Seismic Walkdown Checklist (SWC)

Equipment ID No: Q2N23FI3229CB Equip. Class: 18

Equipment Description FEEDWATER INTAKE FLOW INDICATION

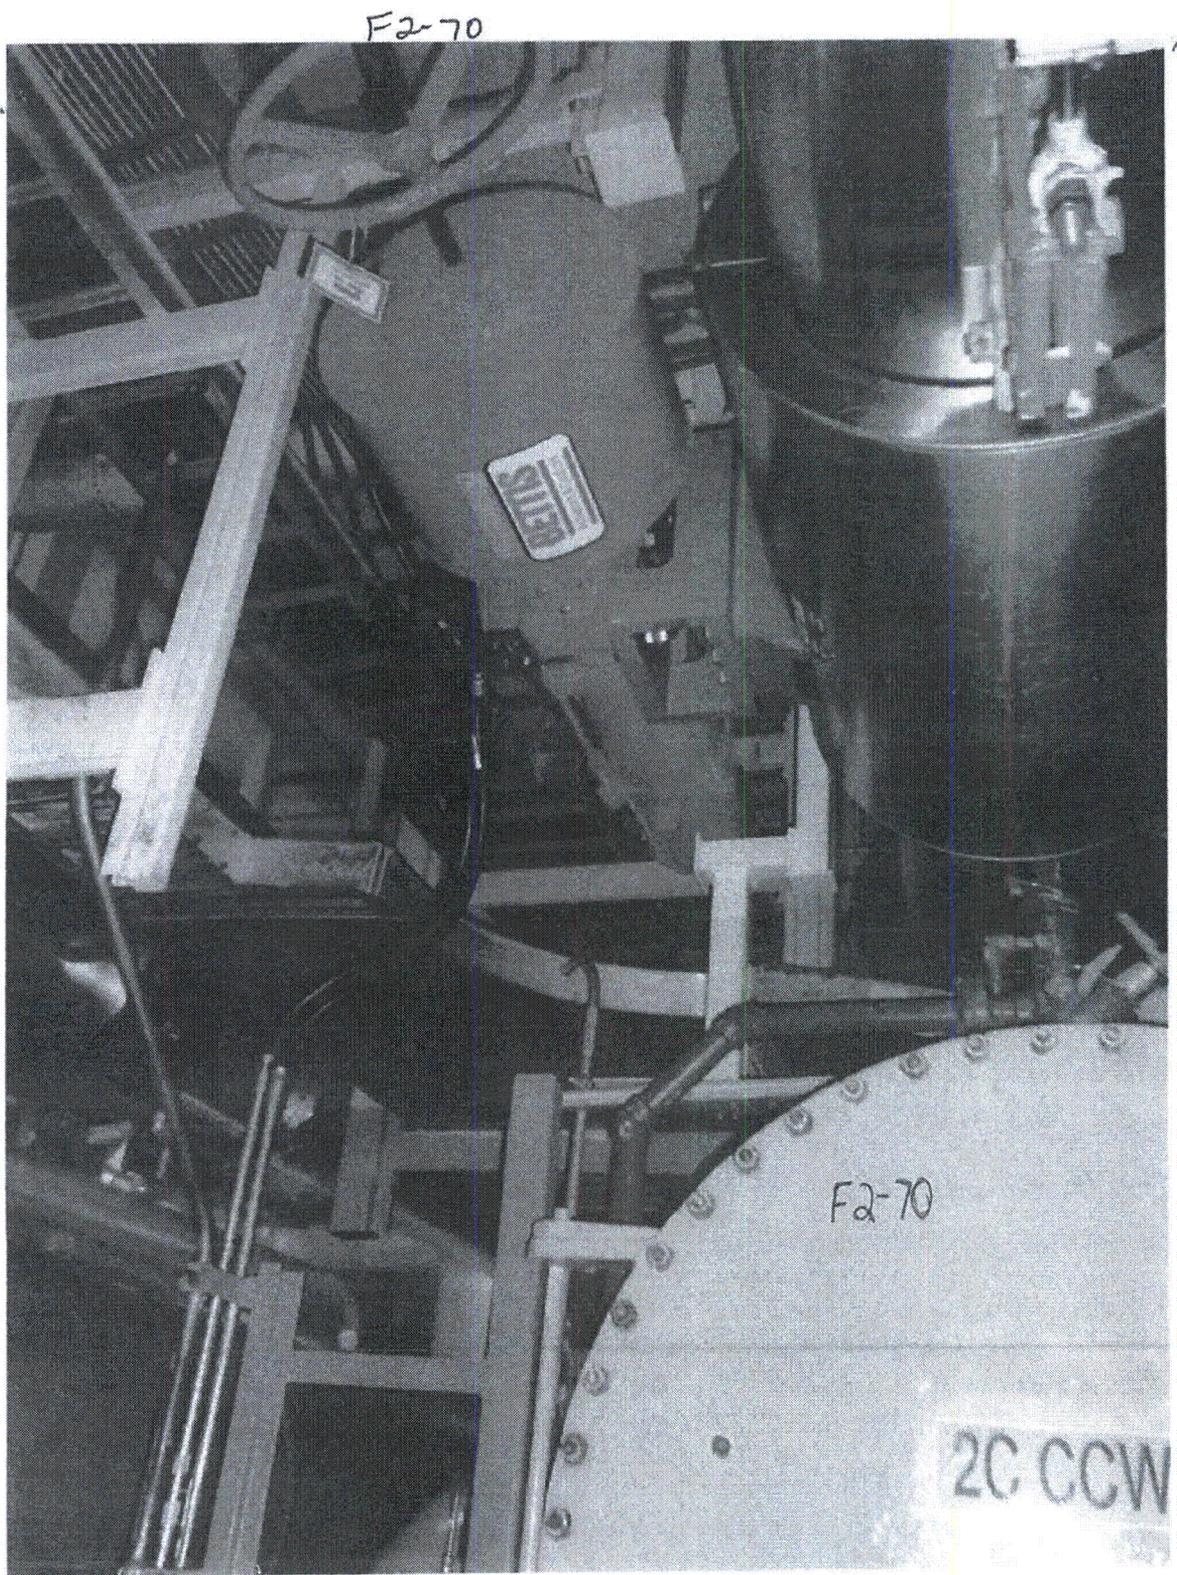
No tag attached to valve however the conditions/layout in the field matches the equipment layout as shown in drawings U-732832 (V.2.0), U-732963 (V.2.0), D-515221 (V.3.0) & D-205466 (V.1.0).
